**CITY OF NORTH ST. PAUL PLANNING COMMISSION  
REGULAR MEETING AGENDA  
THURSDAY, AUGUST 13TH, 2020  
6:15 PM**

Date: 8/11/2020  
To: Planning Commissioners  
From: Erin Perdu, AICP, City Planner  
Morgan Dawley, PE, City Engineer  
CC: Scott Duddeck, City Manager  
Re: Preliminary/Final Planned Unit Development, Site Plan Review and Preliminary/Final Plat for development of 12 townhouse units at the Intersection of Delaware Avenue and 17<sup>th</sup> Avenue (2329 17<sup>th</sup> Avenue E).

Paul Bruggeman is requesting approval of a Preliminary/Final Planned Unit Development (PUD), Site Plan, and a Preliminary/Final Plat to facilitate the development of a revised concept (October 2019) for 12 townhouse units at 2329 17th Avenue E. The subject site is a vacant, City-owned, 2.48-acre parcel.

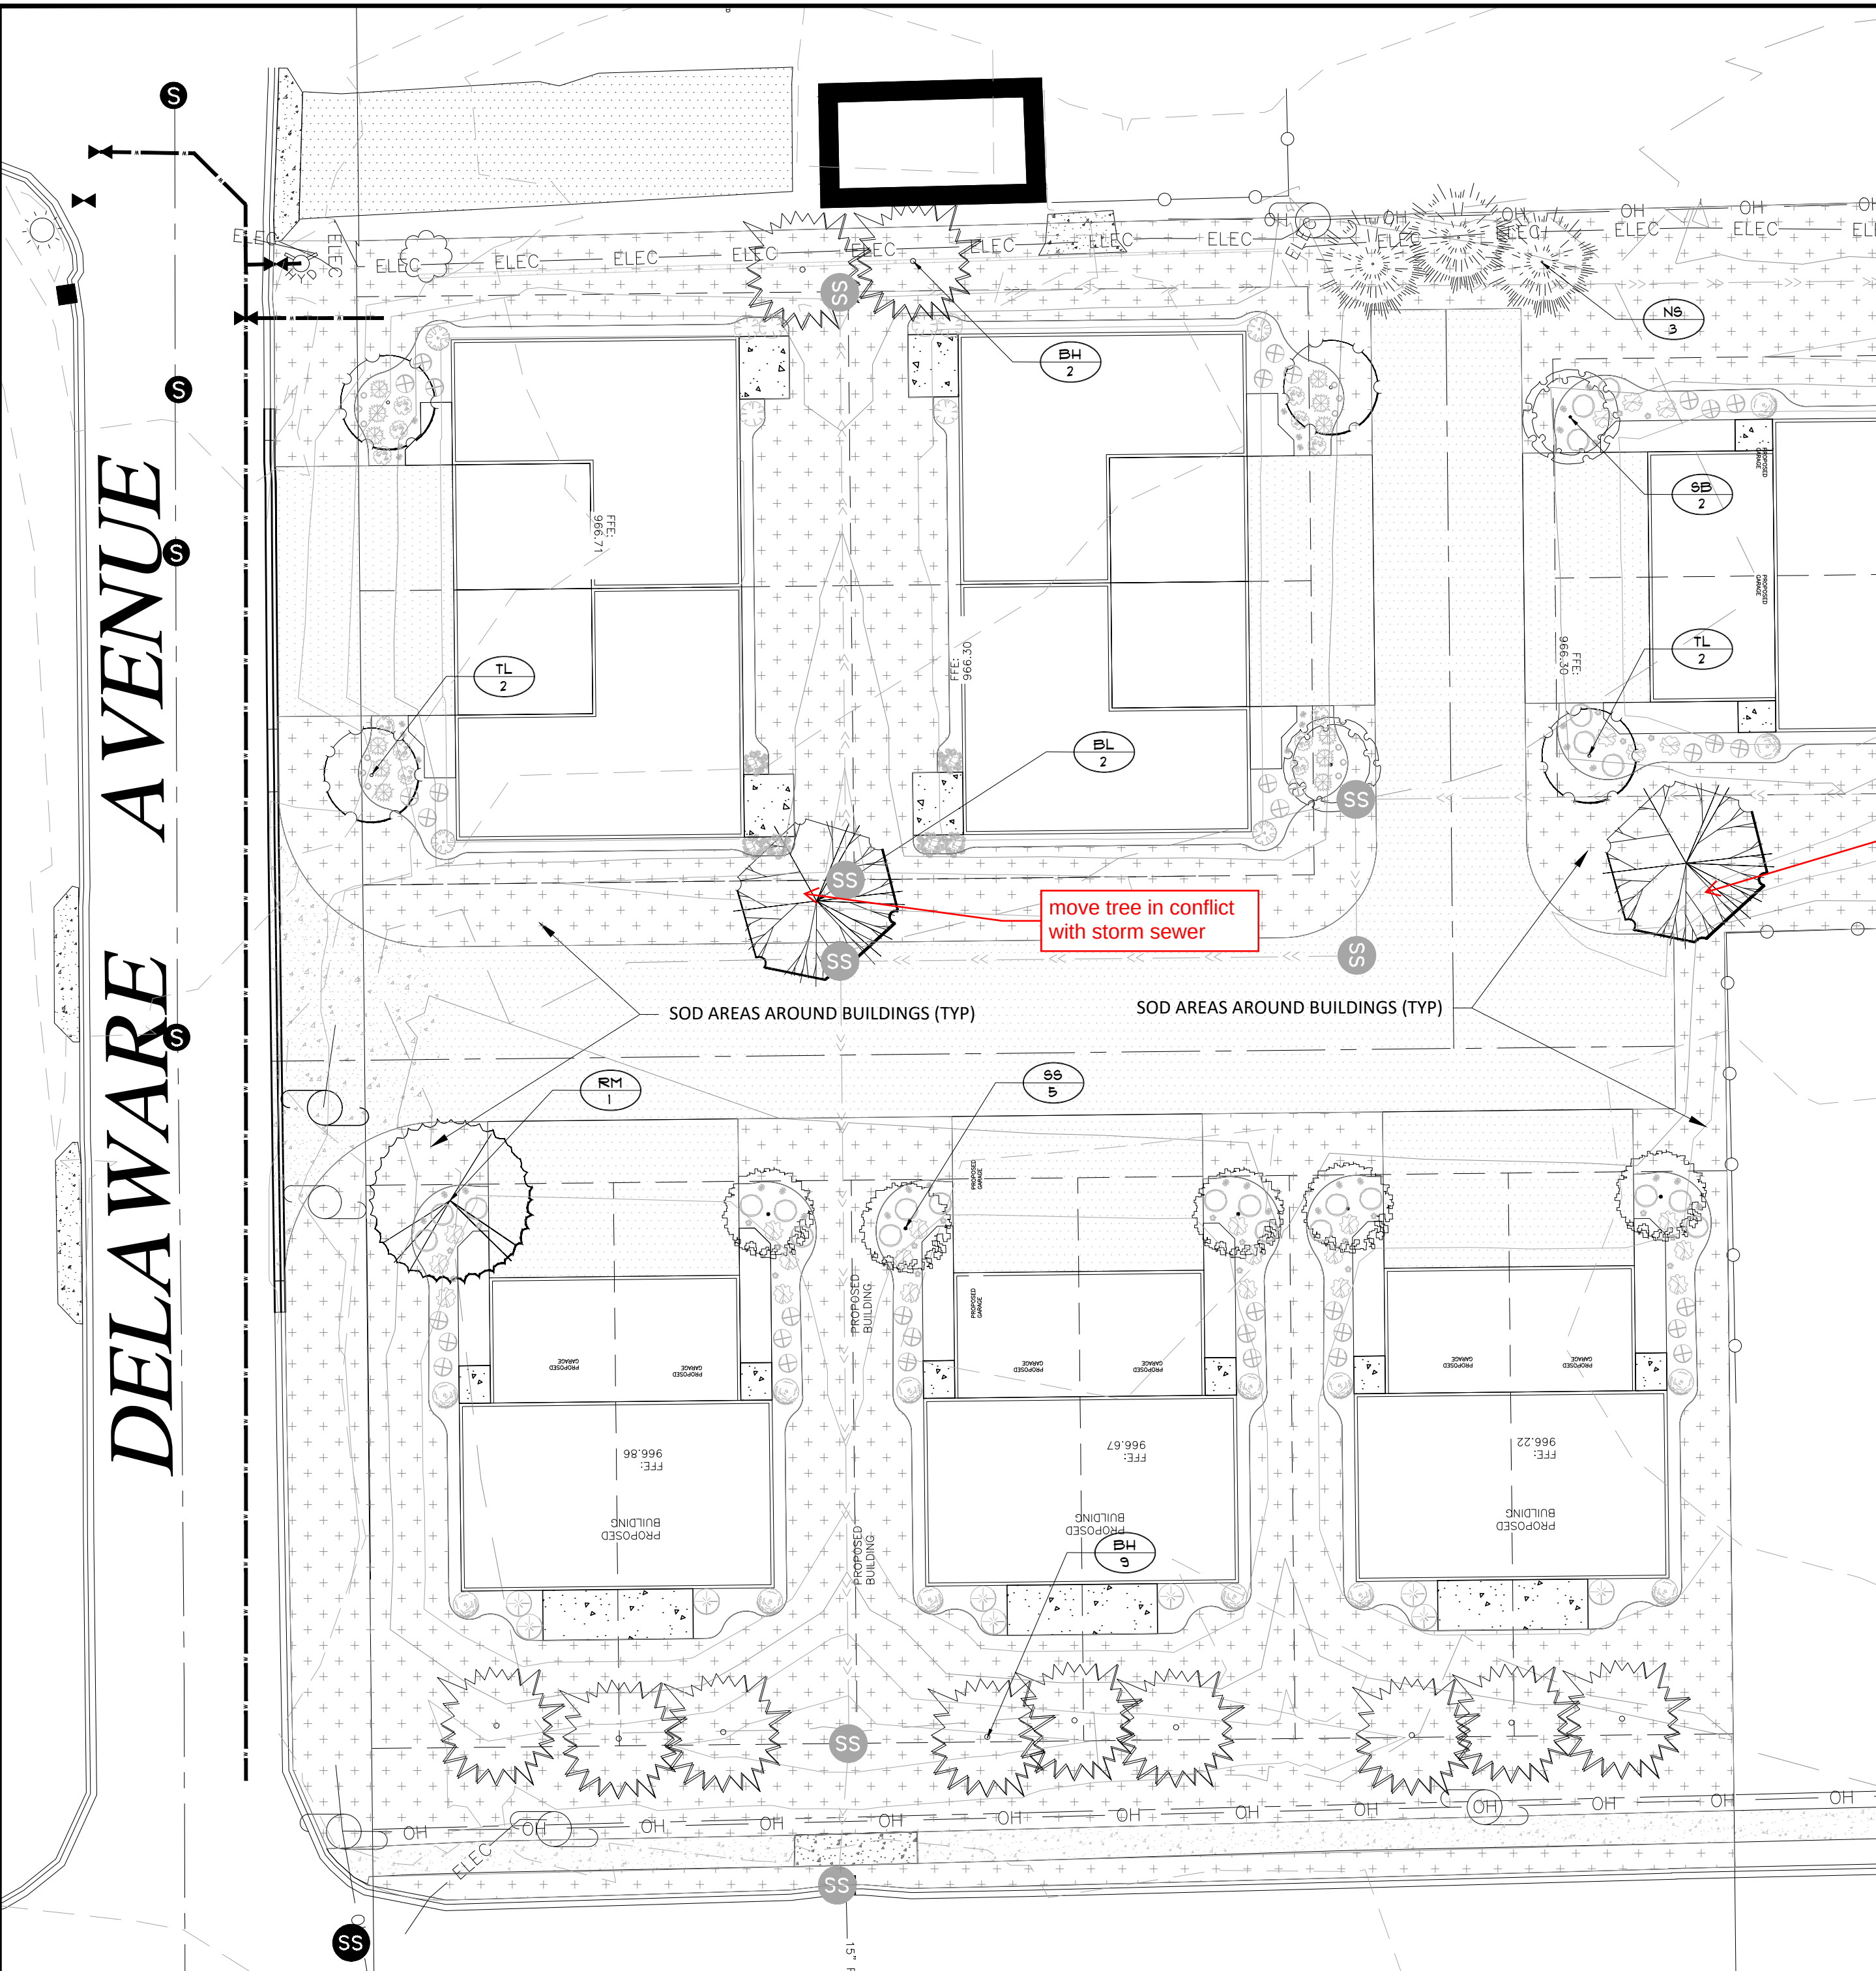
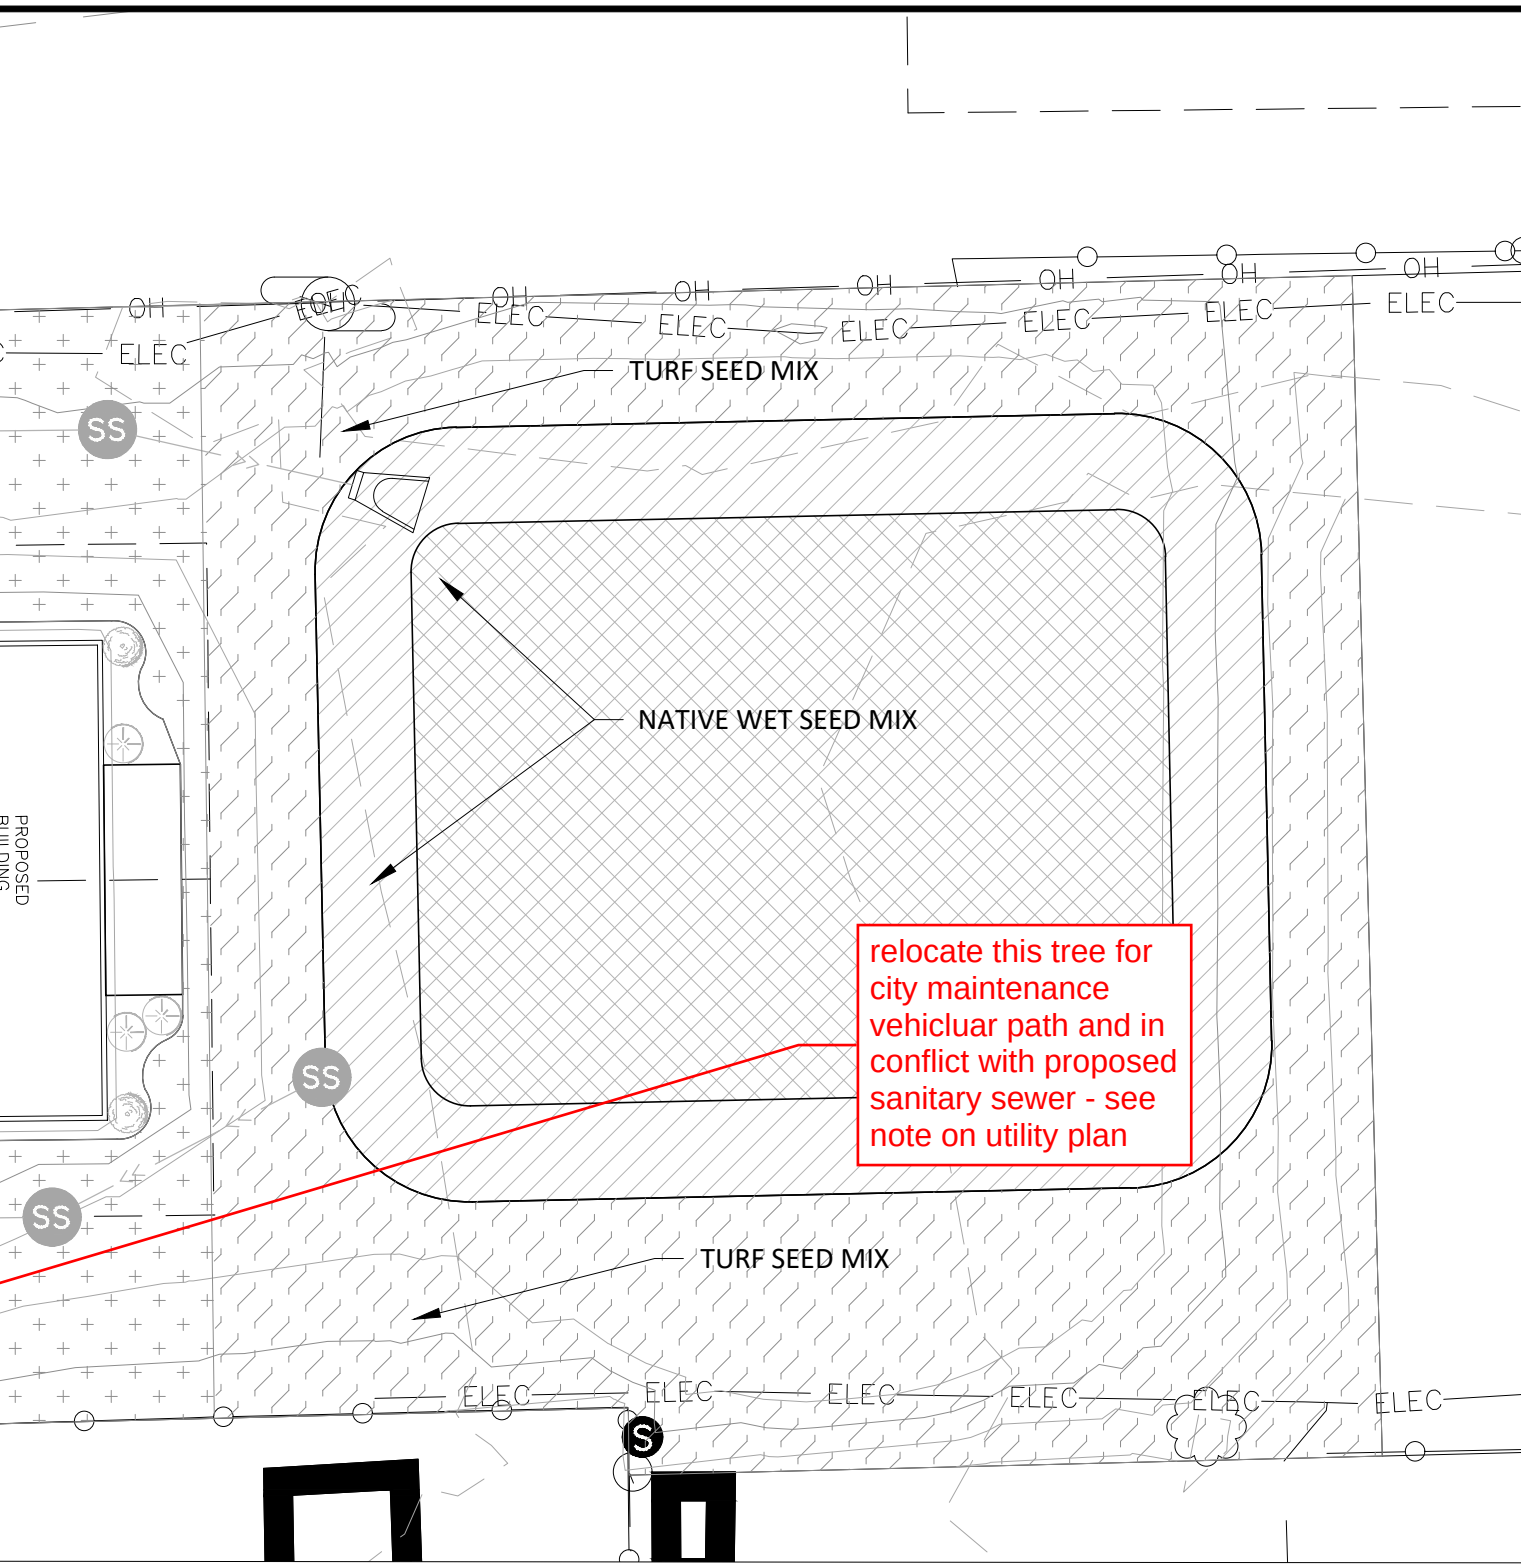
The landscaping plan shows some plantings in the proposed drainage and utility easements shown on the plat. Certain elements are allowed within the easement area per the City Engineer. Accordingly, staff recommends a condition that if the City Engineer determines proposed landscaping conflicts with the easements, said plantings should be relocated.

The landscaping plan shows no plantings within both the intersection of 17<sup>th</sup> Avenue and Delaware Avenue and the private drive intersection with Delaware Avenue.

The submitted elevations show that air conditioning units would be located on the side of the units. The submitted site and landscaping plans do not show any screening measures for these units. These units must be screened from view or located behind a balcony per 154.010(D)(45)(c) above.
